SUBJECT: Savannah River Site's Responses to the Regulatory Comments on the Effectiveness Monitoring Report for the Monitored Natural Attenuation (MNA) at the Chemicals, Metals, and Pesticides (CMP) Pits Operable Unit (OU) (U) April 2019 through March 2020 (SRNS-RP-2020-00291, Revision 0, June 2020) SEMS Number: 24

SRS Responses to EPA Comments on the Effectiveness Monitoring Report for the Monitored Natural Attenuation (MNA) at the Chemicals, Metals, and Pesticides (CMP) Pits Operable Unit (OU) (U) April 2019 through March 2020 (SRNS-RP-2020-00291, Revision 0, June 2020) SEMS Number: 24

SRS Responses to USEPA Comments on the Effectiveness Monitoring Report for the EFFECTIVENESS MONITORING REPORT FOR THE MONITORED NATURAL ATTENUATION (MNA) AT THE CHEMICALS, METALS, AND PESTICIDES (CMP) PITS OPERABLE UNIT
 APRIL 2019 THROUGH MARCH 2020
 SRNS-RP-2020-00291; REVISION 0; DATED JUNE 2020

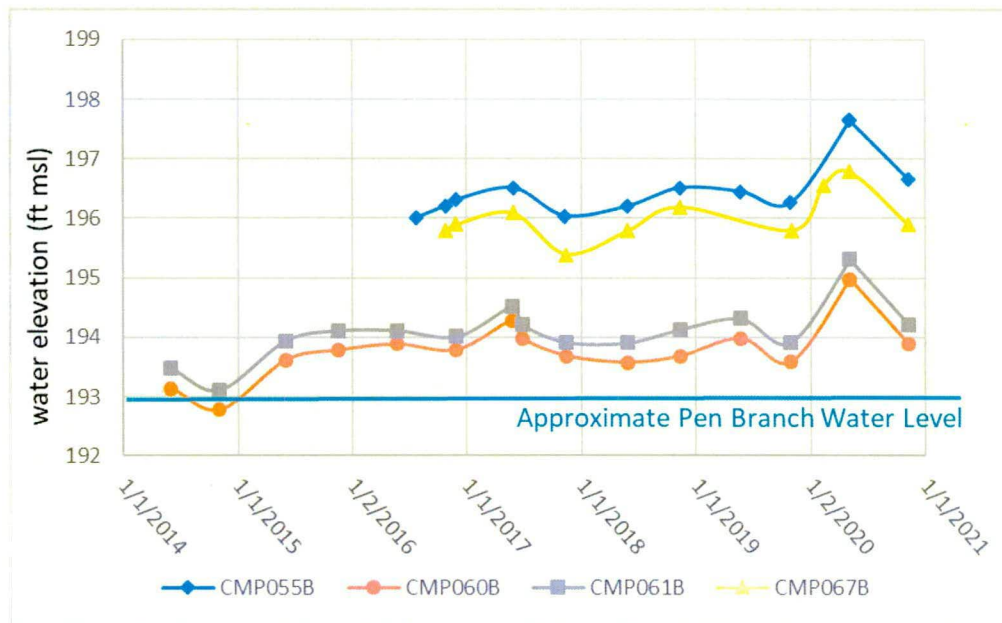
- 3. Section 1.4, Observed Hydrology at the CMP Pits OU, Page 5 of 100:** Based on the data, it is uncertain whether contaminants on the southern side of Pen Branch are not flowing underneath the stream to the north, as indicated in the text. For example, the text states “Measurements show that groundwater in the vicinity of Pen Branch flows toward Pen Branch on both the southern and northern side of the stream, further supporting that contaminants originating south of Pen Branch from CMP Pits are not flowing underneath Pen Branch towards the north. Water elevations in the LAZ on the north side of Pen Branch are higher than elevations on the south side of Pen Branch.” However, according to Figure 8, 2019 Potentiometric Surface for the LAZ and GA, Page 43 of 100, the water level for LAZ well CMP067B located north of Pen Branch was 195.8 feet (ft) mean sea level (msl) and

lower than the 196.26 ft msl water level measured for LAZ well CMP055B located southeast of CMP067B and south of Pen Branch indicating potential flow to the northeast.

The uncertainty of whether contaminants on the southern side of Pen Branch are flowing underneath the stream to the north and a necessity of a current supporting CSM are retained as project needs and for future core team discussion.

Response: Disagree

SRS believes the depiction of the LAZ water table elevation is accurate, especially with the additional well installations over the last 5 years. The gradient between wells CMP055B and CMP067B shown on Figure 8 is 0.46 feet over 800 feet, whereas the gradient between CMP055B and CMP061B to the southwest is 2.35 over 300 feet, indicating flow is about parallel to Pen Branch. Additionally, the water elevation of the Pen Branch stream between well CMP055B and CMP067B is lower than the elevation of the water table (see graph below), which supports flow on both sides of the stream towards the Pen Branch. SRS will continue to monitor the wells on the north side of Pen Branch (CMP067B and CMP066B) on a semiannual basis (Also see response to General Comment #1).

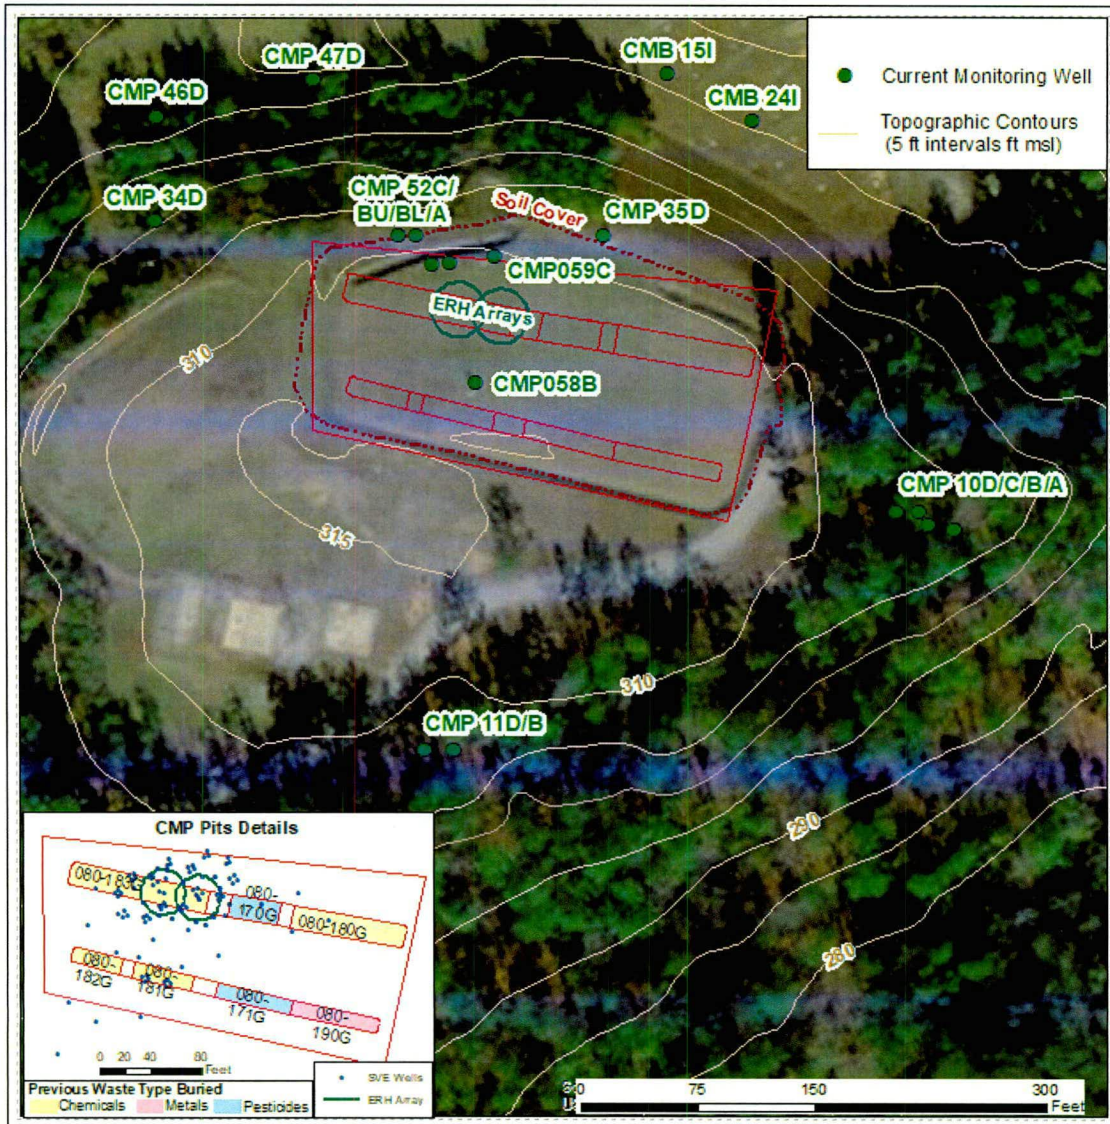
- Section 2.2.2.1, Groundwater Aquifers, Page 12 of 100:** Total dissolved mass estimates were not presented for each COC over time (e.g. 2008 through present) for each aquifer zone. As such, an evaluation could not be performed on whether the total estimated dissolved masses over time are declining for each COC (i.e., horizontally and vertically), and if the

total mass is being reduced for each aquifer zone as a supporting line of evidence for natural attenuation, consistent with the EPA MNA Guidance.

Documented reduction in total contaminant mass over time in each aquifer zone is retained as a project need and for future core team discussion and inclusion future reporting efforts.

Response: Clarification

The documented removal of total contaminant from remedial efforts had been reported in the annual EMRs since the approval of those remedial efforts. However, an estimate of the total dissolved mass has not been calculated for each COC over time in general and specifically not for each aquifer zone. Qualifiable evidence of a reduction of mass is presented with the general trends discussed and presented in the reports, as well as, estimates in the modeling that has been performed to better understand the distribution and dissolution of the plume. As such, a discussion of the project need for a mass estimate is welcomed.
